## Servicing SW 2010, X 8SUB, and E 8SUB

Fuses F401 and F402 must be changed from T3.5A/125V to T5A/125V.

Fig. 1 - Cross out the fuse rating

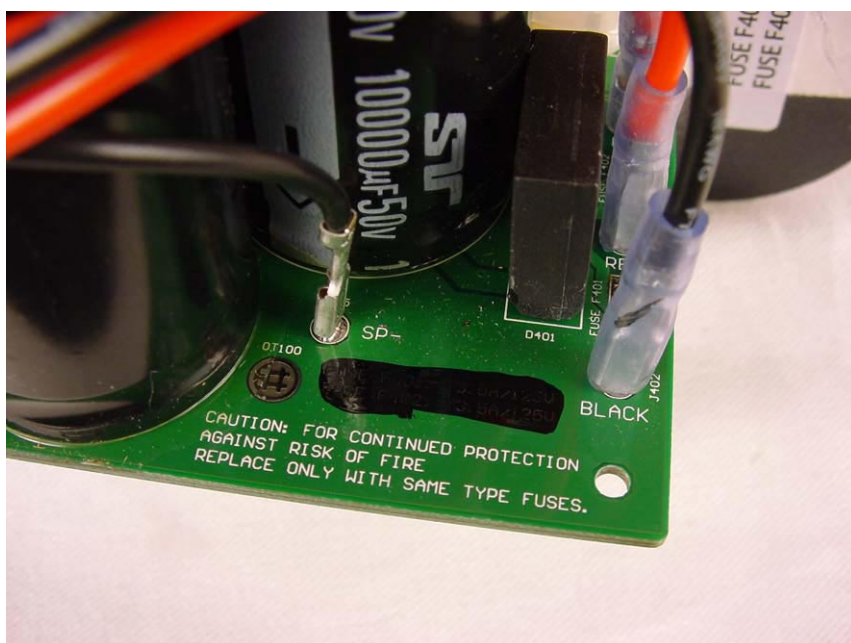
- Fuses
  - Label for mounting on the back panel
  - Pictures showing placement of fuses and label (Fig. 1 and Fig. 2)
  - Instructions as to how the change is carried out:
- 1 Remove F401 and F402
  - 2 The two new fuses are soldered onto the PCB applying minimum heat as otherwise the fuses will be damaged
  - 3 Cross out the fuse rating on the PCB (see Fig. 1)
  - 4 Place the label on the back panel (see Fig. 2)
